Access Compliance Report

Public Rights-of-Way

(Curb Ramps)

Intersection ID: 9551	Main Street: EASTWAY_DR	Cross Street: HOWIE_CR	Location: NW
ADA ID: 725FFCA016A	Ramp Type: Perp	Initial Pass/Fail: Fail	Overall Compliance: No
Codes/Mitigation Info/Possible Solution		Field Measurements/Component Compliance	
Severity Score: 21.25

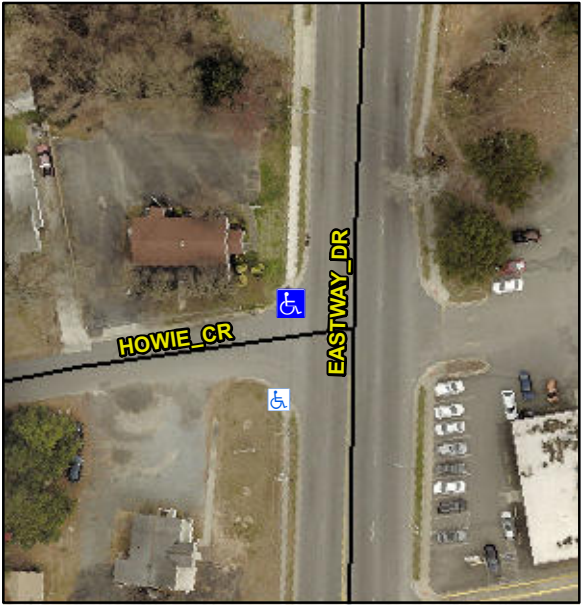
Possible Solutions:	Compliance	Description	Data	Compliance	Description	Data
	Remove & Replace Entire Ramp.	N/A	Ramp Length (in)	58.5	No	Ramp Slope (%)	9.6
		No	Ramp Width (in)	40.0	Yes	Ramp XSlope (%)	1.9
		N/A	Flare Type LT	N/A	N/A	Flare Type RT	N/A
		N/A	Flare Slope LT (%)	N/A	N/A	Flare Slope RT (%)	N/A
		N/A	Flare Traversable LT?	N/A	N/A	Flare Traversable RT?	N/A
		N/A	Landing Length (in)	N/A	N/A	DWS Provided?	N/A
		N/A	Landing Width (in)	N/A	N/A	DWS Contrast?	N/A
		N/A	Landing Slope (%)	N/A	N/A	DWS Length (in)	N/A
		N/A	Landing X Slope (%)	N/A	N/A	DWS Full Width?	N/A
		N/A	Landing Curb? (Y/N)	N/A	N/A	DWS Offset (in)	N/A
		N/A	Shared Landing?	N/A			
		N/A	Gutter Ponding?	N/A	N/A	Gutter Slope (%)	N/A
		N/A	Gutter Lip Ht (in)	N/A	N/A	Gutter X Slope (%)	N/A
		N/A	Painted X Walk1?	No	N/A	Painted X Walk2?	N/A
			X Walk 1 Direction	To S		X Walk 2 Direction	N/A
		N/A	X Walk 1 Width (in)	N/A	N/A	X Walk 2 Width (in)	N/A

X Walk 1 Slope (%)	3.1		X Walk 2 Slope (%)	N/A
			X Walk 1 X Slope (%)	1.2		X Walk 2 X Slope (%)	N/A
		N/A	Ramp inside XWalk1?	N/A	N/A	Ramp inside XWalk2?	N/A
<p>Surveyor Notes:</p> <p>N/A</p> <p>PROW/ADA:</p> <p>Not Found, R304.5.1, R304.2.2</p>			Road Slope (%)	N/A	N/A	Clear Space?	N/A
			Road X Slope (%)	N/A	N/A	Clear Space to XWalk (in)	N/A
Total Cost:			Any Obstructions?	N/A	N/A	Storm Grate/Utility Hazard?	N/A
			Obstruction Type			Storm Grate/Utility Type	
					N/A		N/A
					Yes	Surface Condition? (G/P)	Good
